NRC Review of AP1000 Analytical Codes and Test Programs

**Stephen M. Bajorek, Ph. D.
Office of Nuclear Regulatory Research
United States Nuclear Regulatory Commission
Ph.: (301) 415-7574 / smb4@nrc.gov**

**AP1000 Design Workshop
August, 2007**

Upper Plenum "Pool" Entrainment

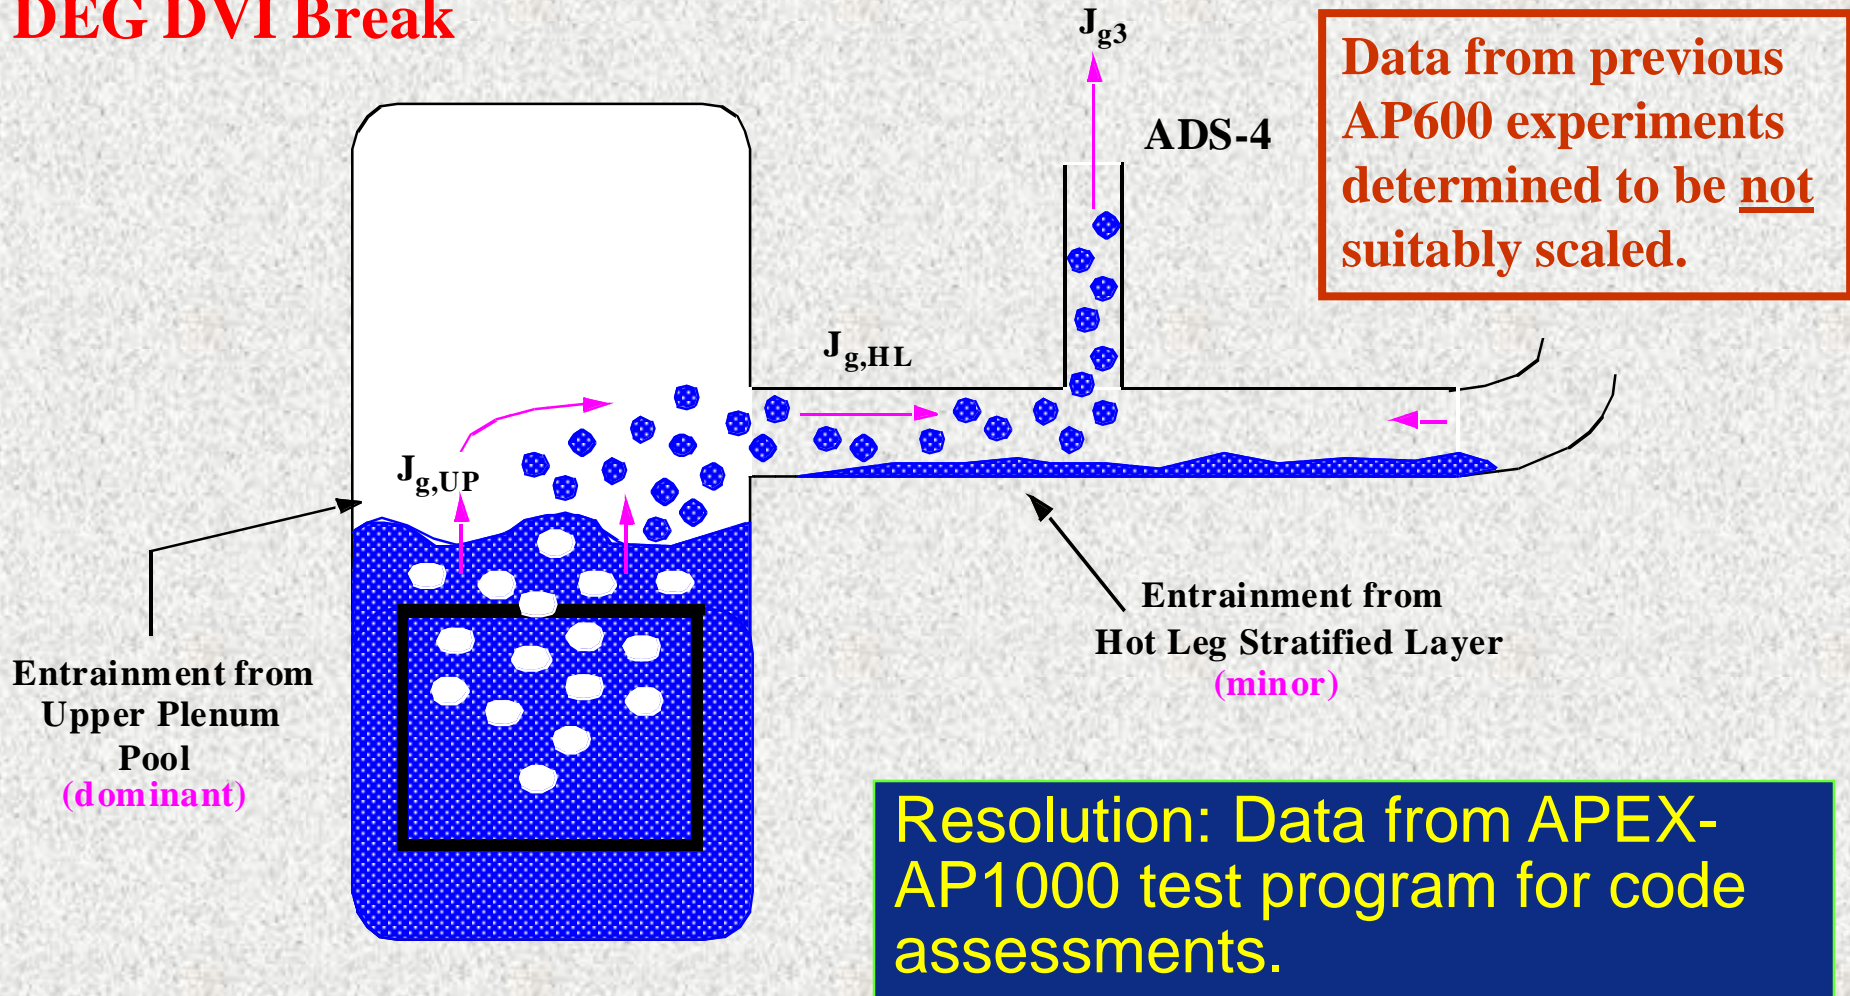
Small Cold Leg Break

Unique geometry and lack of applicable data & correlations made process un-scalable.

Resolution: Data from ATLATS test program and bounding calculations.
